### ANN ARBOR HISTORIC DISTRICT COMMISSION

### **Staff Report**

ADDRESS: 544 Third Street, Application Number HDC24-0141

**APPLICATION:** The applicant seeks HDC approval to replace 11 non-historic windows and a non-historic sliding glass door on post-1945 additions to the house.

### Window G

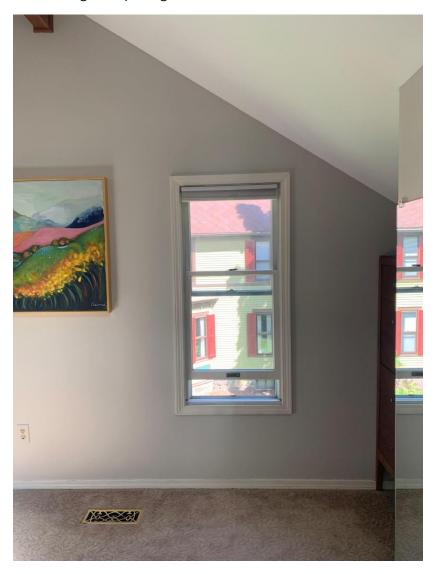
Bedroom west current size: 26" wide x 41" tall

Bedroom west new size: 36" wide x 41" tall
